UNITED STATES PATENT AND TRADEMARK OFFICE

APPLICATION NO.	FILING DATE	FIRST NAMED INVENTOR	ATTORNEY DOCKET NO.	CONFIRMATION NO.
10/750,312	12/30/2003	Jessica R. DesNoyer	50623.313	1694

Office Action Summary

**FIG. 5A**

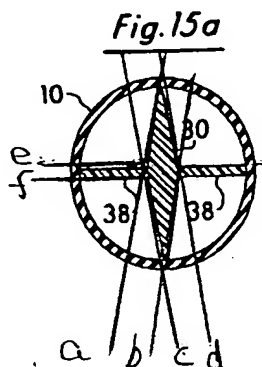
arguments, there is a practical way to describe the invention, different configurations of the mandrel body, in words and therefore, the examiner maintains that the inclusion of the drawings in claim 17 to depict the shape of the mandrel body is improper (see 37 CFR 1.58). Further, although the examiner agrees that applicant can be his or her own lexicographer, the examiner maintains that claim 16 is indefinite since it unclear what the claim encompasses, that is, it fails to clarify the metes and bounds of the claim. For example, applicant refers to configuration 2 as depicted in figures which include Figure 5A and it is unclear when applicant claims the mandrel body has the shape of configuration 2 whether applicant intends to claim that the angle of the inclined side of the vertically oriented upper spike with respect to a normal to the horizontal axis which passes through the center of the star and the peaks of the horizontal spikes is about 17.5 degrees or not. See the drawing below:

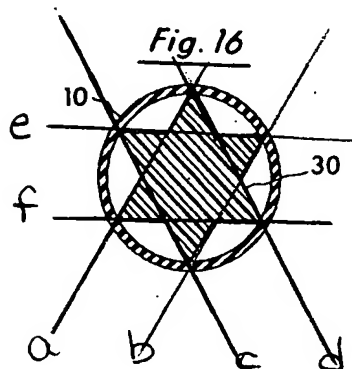
Applicant's argument that Figures 15a and Figure 16 fails to include 3 pairs of opposing parallel sides is found to be non-persuasive. The examiner maintains that

drawings 15a and 16 include at least 3 pairs of opposing parallel sides as depicted

below.

The at least 3 pairs of
opposing parallel
Sides:
1st pair - a, b
2nd pair - c, d
3rd pair - e, f
